From: [Ackerman, Jeffrey A - DNR](#)
To: ["jeff.miesen@moundcitybank.com"](mailto:jeff.miesen@moundcitybank.com); [Kollasch, Tony](#)
Cc: [Gilkey, Keith](#)
Subject: Questions about the Soil Vapor Extraction Pilot Test - Highway Cleaners (Boscobel)
Date: Monday, October 4, 2021 11:11:00 AM

This is in response to [SCS's soil vapor extraction \(SVE\) pilot test status report](#) (report). I have several questions about the report and the project status.

Figure 3. Example vapor concentration data from an SVE pilot test

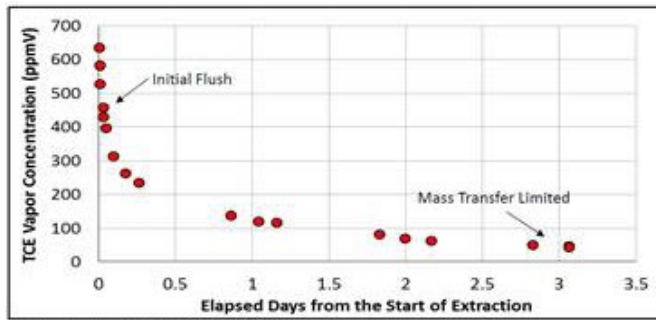
4. How will soil vapor concentrations likely diminish with time with continued soil vapor extraction? Might the trend be consistent with those illustrated in [EPA guidance](#)?
